Report on  
Inspection of Leaks and Cracks in the  
(A) Steam Generator at H. B. Robinson II

Report No. DC 89

June 23, 1971

Prepared for: U. S. Atomic Energy Commission  
Division of Compliance  
AEC Contract AT (11-1)-1658  
Subcontract No. 10

FIG. 1  
"A" STEAM GENERATOR

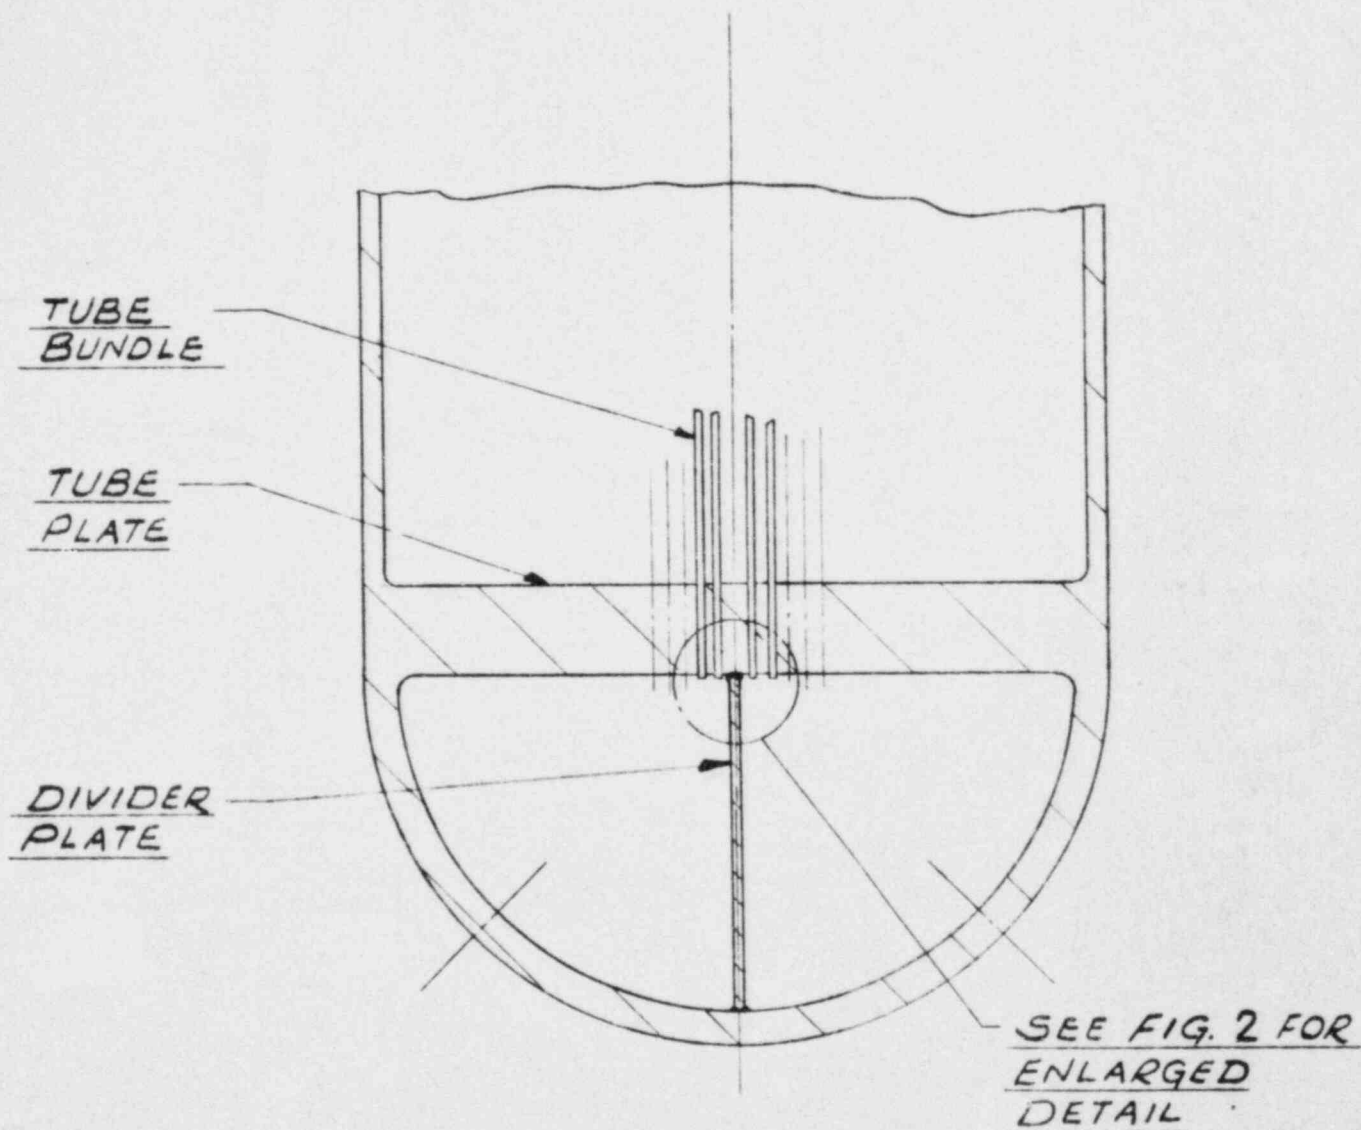
Mr. Kirkpatrick and the writer were "suited-up" and proceeded to enter individually and inspect the cold leg of the A steam generator. The inspection was performed visually using a low power magnifying lens. Mr. Kirkpatrick attempted to photograph the conditions we observed with a 35 mm. camera using a close-up lens. The following conditions were observed during this inspection: (See Figs. 1, 2 & 3)

- (1) Severe cracks were present in the fillet welds of approximately 30 tubes. The highest intensity of fillet cracking was apparent in the region included in and surrounding the 35th

to 45th tubes (as counted from the north towards the south).

- (4) The writer visually observed a contoured region of the cladding, adjacent to the divider plate and in the vicinity of the 40th to 50th tubes that showed definite signs of having been separated from the tube sheet.

FIG. 2  
ENLARGED VIEW OF  
CLAD SEPARATION

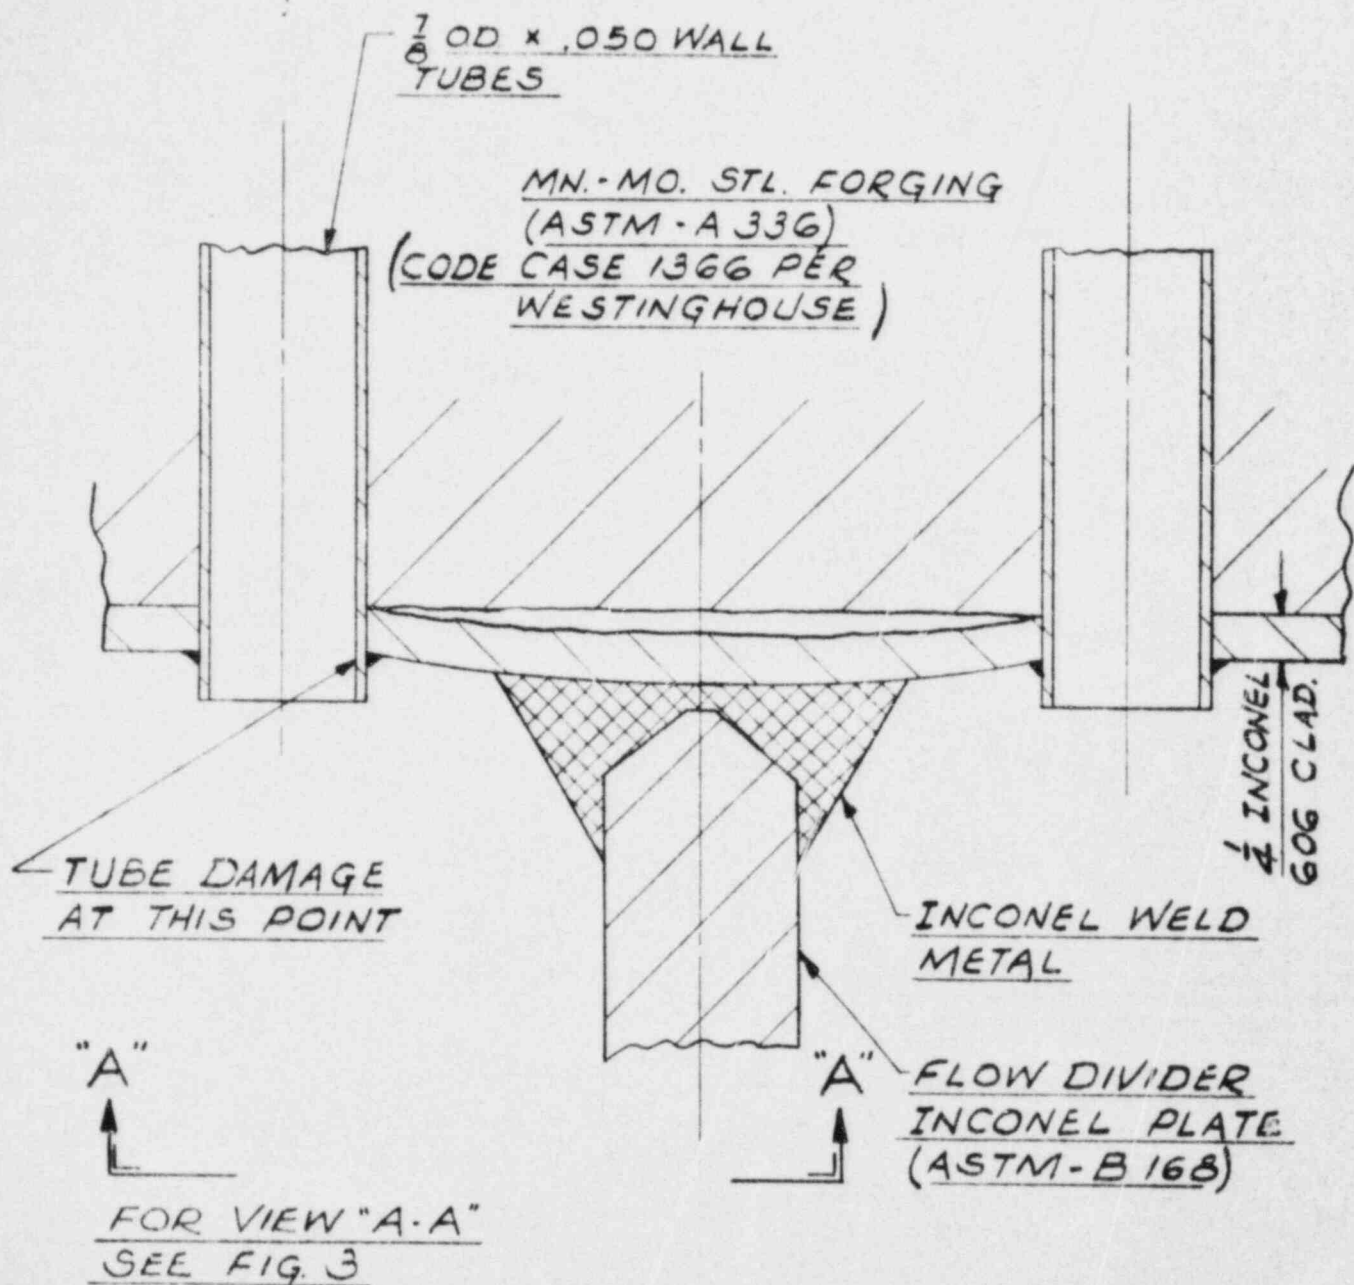
These cracks were opened approximately .030 to .050 inches and were approximately semi-circular on the side of the fillet welds facing the flow divider plate.

- (2) Cracking in the 1/4 inch thick cladding was extensive in the region described above. These cracks were linear in the north-south direction (parallel to the divider plate) and were located approximately in line with the center of the first row of tubes. These cracks were tighter than those observed in the fillets and appeared to range in the vicinity of .005 to .010 inches wide and extended the entire length of the cladding between the cracked tubes.

- (3) Rusting and corrosion products were observed in the immediate vicinity of the fillet weld cracks progressing into the cladding cracks. This evidence shows that galvanic action and electrochemical corrosion has already occurred between the tube sheet material and the austenitic materials involved, through the borated solution which acted as an electrolyte.

FIG. 3  
VIEW "A-A"  
FROM FIG. 2

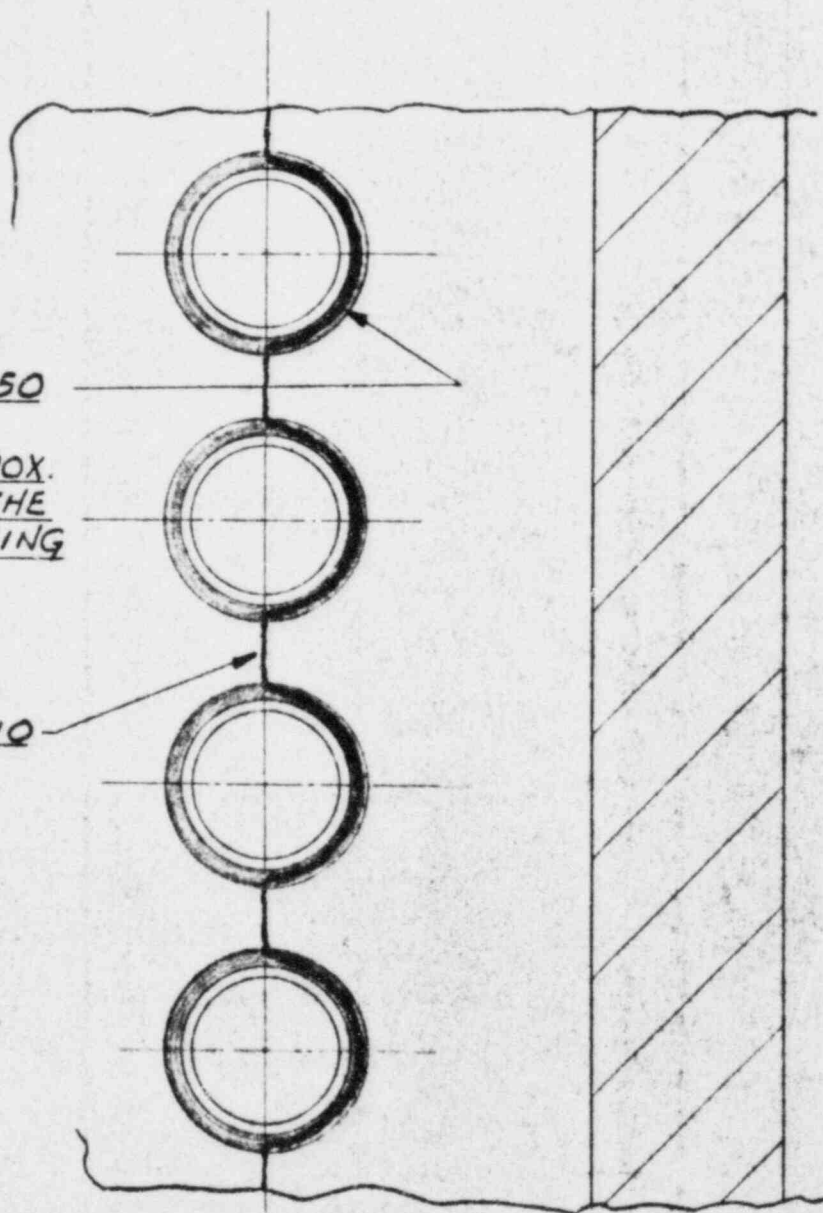
APPROX. .030 TO .050  
WIDE CRACKS IN  
FILLET WELDS APPROX.  
SEMI-CIRCULAR ON THE  
SIDE OF WELDS FACING  
THE FLOW DIVIDER  
PLATE.

APPROX. .005 TO .010  
WIDE CRACKS IN  
CLADDING APPROX.  
ON  $\frac{1}{2}$  OF TUBES  
EXTENDING THE  
ENTIRE LGTH.  
BETWEEN TUBES.
